PROPOSAL FOR DRAFT AMENDMENTS TO REGULATION No. 80

(Seat anchorages in large passenger vehicles)

Submitted by the experts from Germany and Belgium

Note: The text reproduced below was prepared by the experts from Germany and Belgium in order to introduce prescriptions for side-facing seats in vehicles of category M3 (Class II, III and B).

Figure 1, Positioning requirements for side-facing seats

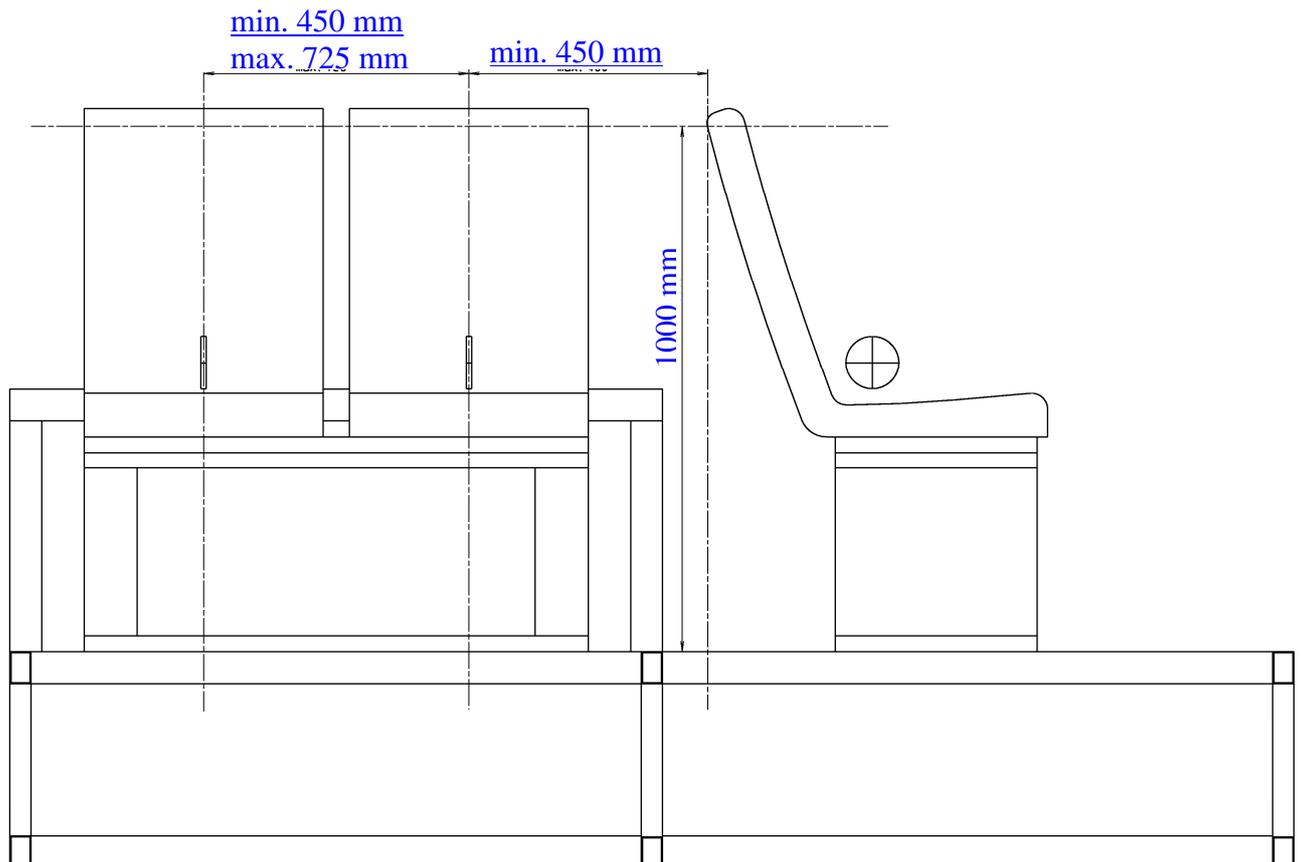
7.4.3. the horizontal distance between the H-point line between two adjacent side facing seats shall not exceed 725 mm and shall not be less than 450 mm, measured horizontally between the vertical longitudinal planes passing through the centres of these seating positions,. (see Appendix 7, figure 1); and

1. The distance between the foremost side-facing seat and the vehicle part forward of this foremost side-facing seat shall not exceed 450 mm. All measurements are to be taken 1000 mm above the foot contact area of the foremost side-facing seat (see Figure 1).

Figure 2 : positioning requirements for the vehicle part forward of the foremost side-facing seat

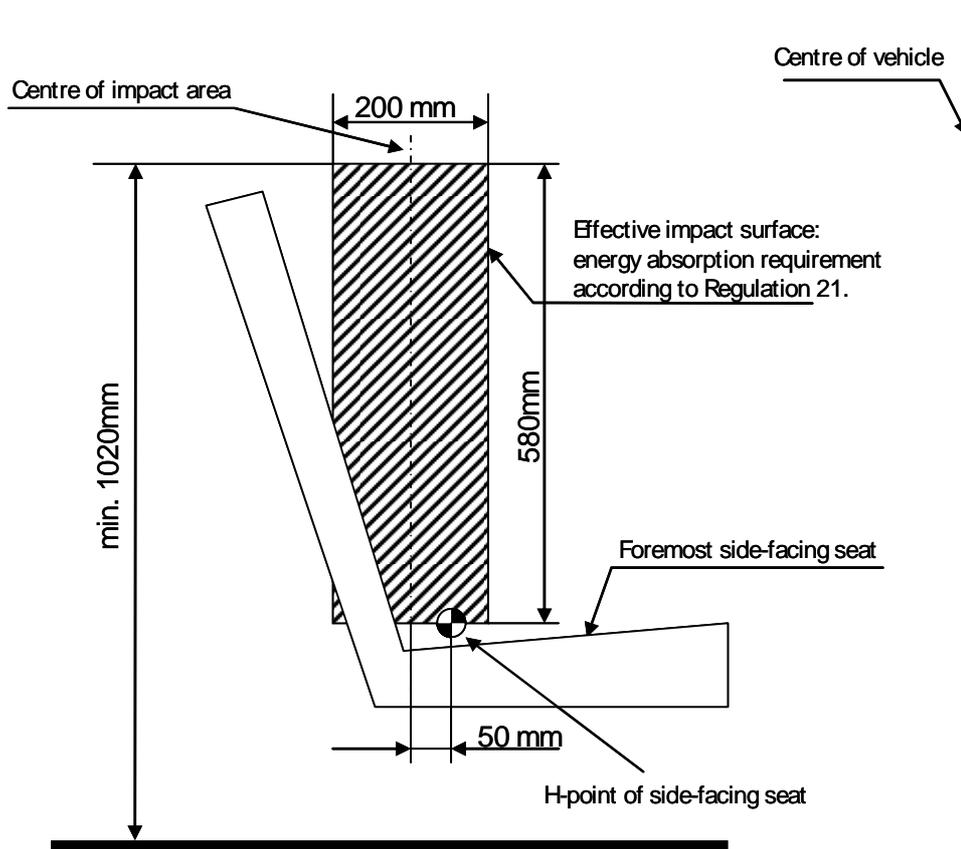
- 2. The vehicle part (e.g. partition, wall or seat back of a forward facing seat) in front of the foremost side-facing seat shall fulfil the following requirements in order to safeguard the passenger in that foremost side-facing seat (see Figure 2):**

- 2.1. The height of the vehicle part, based on the foot contact area of the foremost side-facing seat, must not be less than 1020 mm; and**
 - 2.2. the effective impact surface of the vehicle part has a width of 200 mm and a height of 580 mm. This surface shall be positioned so that the vertical centre-line is located 50 mm behind the H-point of the foremost side-facing seat; and**

- 2.3. the corresponding surface of the vehicle part in place projected onto a vertical plane through this H-point, shall cover at least 95% of the effective impact surface. This vehicle part shall fulfil the energy absorption requirement by appendix 6.**

- 2.3.1. If there is a gap in the corresponding surface (typically two forward-facing seats with a gap in between) a distance shall be determined for each gap by means of a sphere having a diameter of 165 mm. The sphere shall be put into contact with the gap in a point of the gap area which allows the maximum sphere intrusion, considering no load is to be applied. The distance between the two points of contact of the sphere must be less than 60 mm;**
